## 2.3 Radiation Monitoring Systems

The information in this section of the ABWR DCD, including all subsections, tables, and figures, is incorporated by reference with the following departures.

STD DEP T1 2.3-1 (Figure 2.3.1)

STD DEP T1 2.14-1 (Table 2.3.3)

Figure 2.3.1 Process Radiation Monitoring System Control Interface Diagram

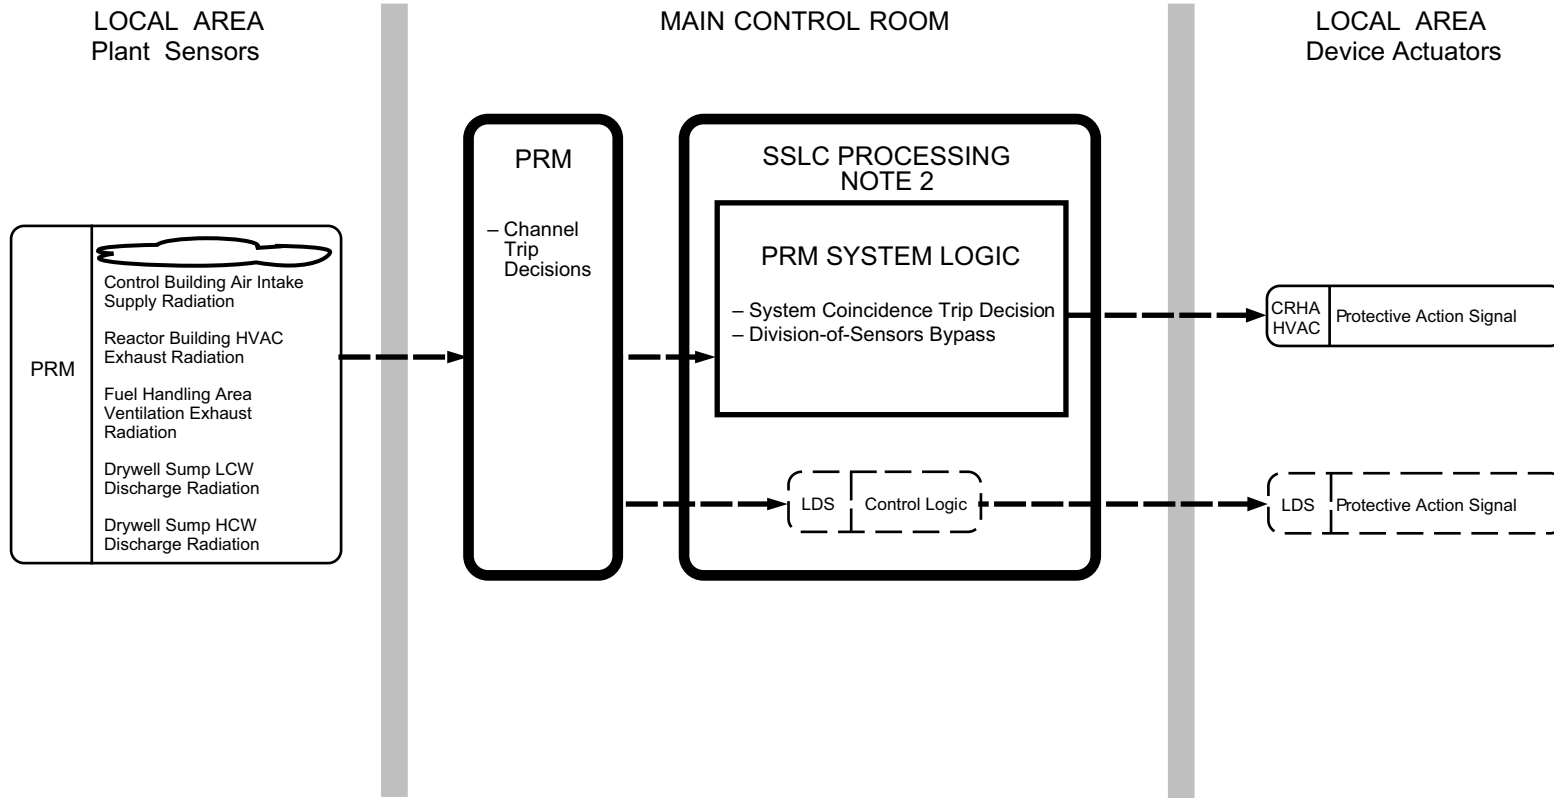
STD DEP T1 2.3-1

*Portions of the PRM System are classified as Class 1E safety-related (items 42 through 5 below); the remainder are classified as non-safety-related.*
